Access Compliance Report Public Rights-of-Way (Curb Ramps)

Intersection ID: 30324 Main Street: FOREST STREAM CT **Cross Street: HIDDEN FOREST DR** Location: NW Ramp Type: PerpDiag Initial Pass/Fail: Pass **Overall Compliance: No Severity Score:** 12.5 **ADA ID: 119EA20CE292**

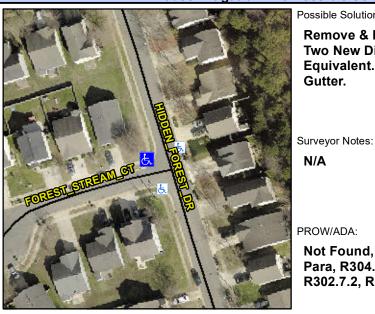
Not Found, R304.2.2-Perp, R304.3.2-Para, R304.5.3, R305.2, R302.7, R302.7.2, R304.5.4

| Compliance Description Data | | Com | pliance Description | Data | |
|-----------------------------|-----------------------|--------|---------------------|-----------------------------|------|
| No | Landing Slope (%) | 2.8 | Yes | DWS Length (in) | 25.5 |
| No | Landing X Slope (%) | 2.6 | Yes | DWS Full Width? | Yes |
| No | Gutter Ponding? | Yes | No | Gutter Slope (%) | 7.5 |
| No | Gutter Lip Ht (in) | 0.5 | Yes | Gutter X Slope (%) | 0.6 |

Possible Solutions: Remove & Replace Curb Ramp With Two New Directional Ramps or Equivalent. Remove & Replace Gutter.
